Page 6 Garage door header calc and building permit application page

445 15th Street SE,
Washington DC 20003
Board of Zoning Adjustment

CASE NO.19747

EXHIBIT NO.002

Roof Frame

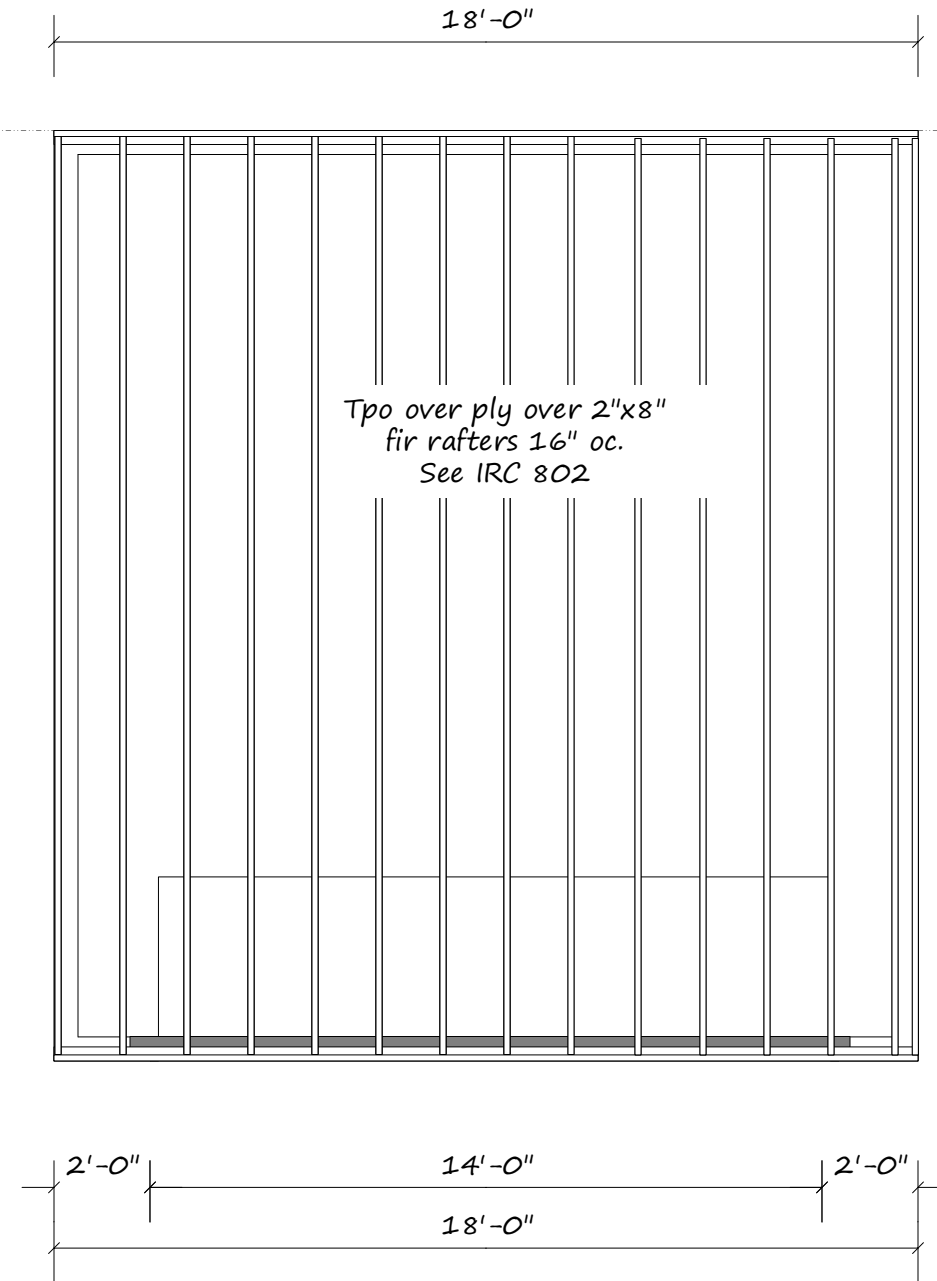
Fix over span rafters by adding sisters

Rafters over span 14'2" max
Add rafters to side

Typ. Slab detail

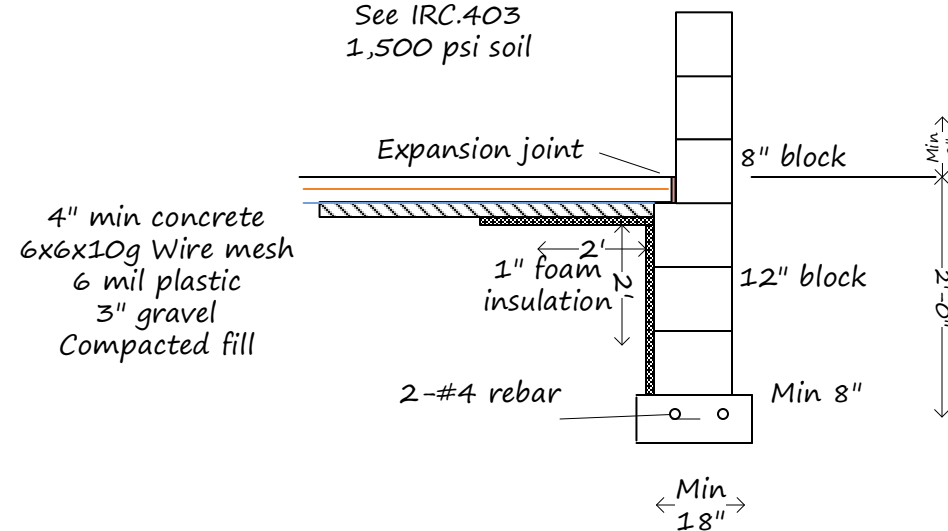
See IRC.403
1,500 psi soil

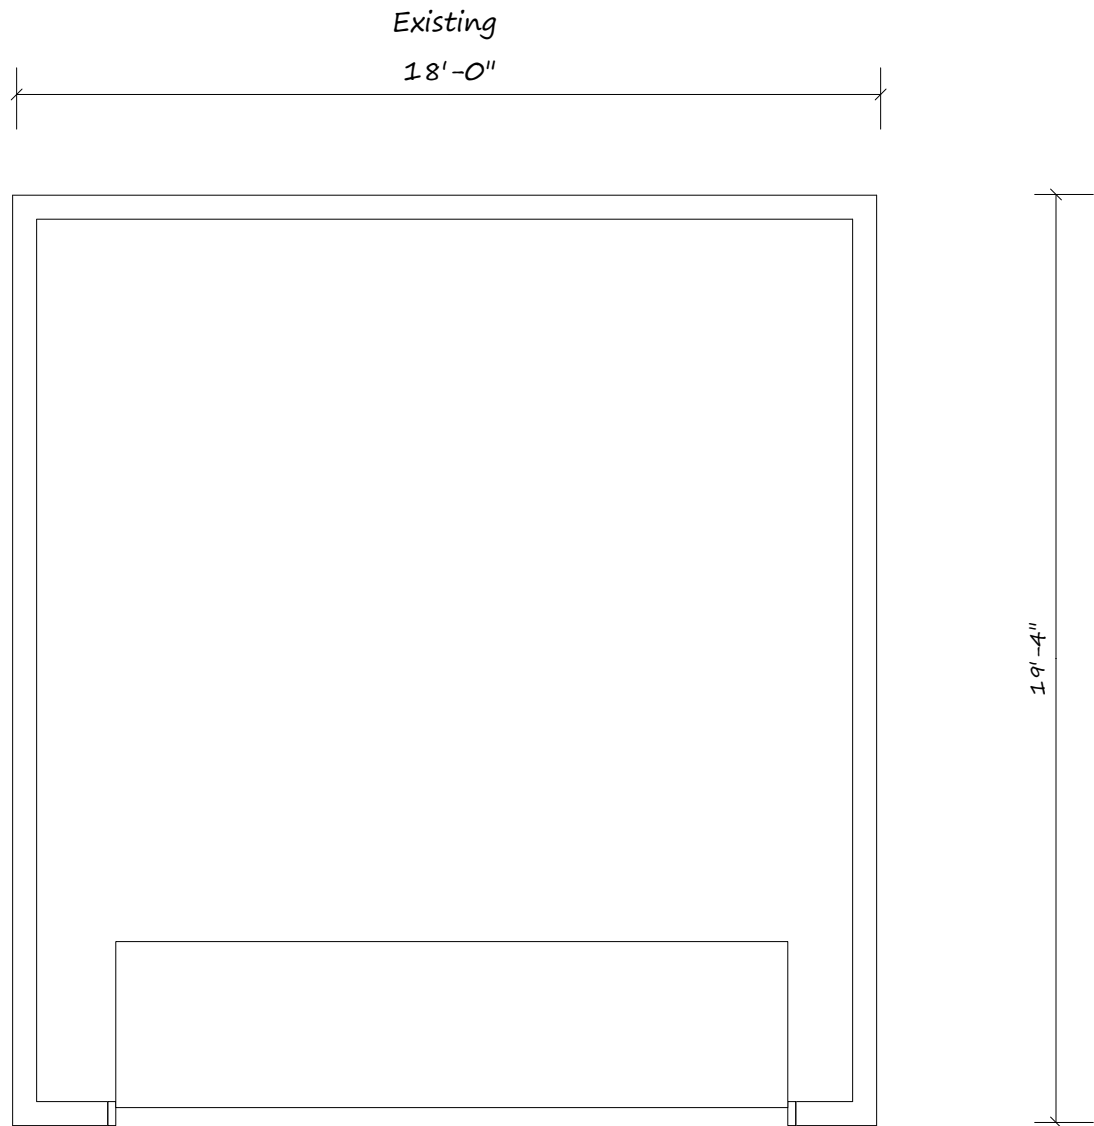
Zoning variance appeal for lot coverage

Existing 347 sq ft
 Needed 240 sq ft
 Allowed 163 sq ft

Building Permit of SQUARE 1062 LOTS 803 - 804
Scale: 1 inch = 10 feet Recorded in Book A & T Page 3320 - N

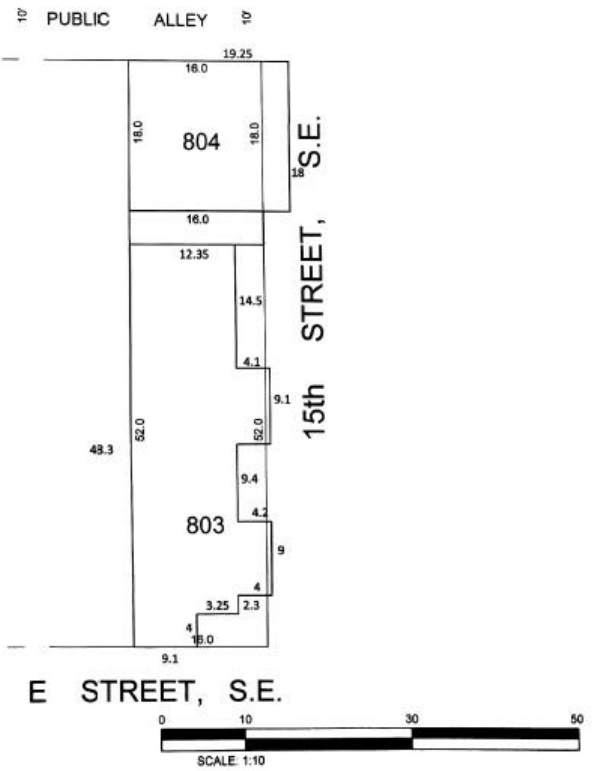
804 and 803 are tax lots and needs subdivision for building lot designation ?
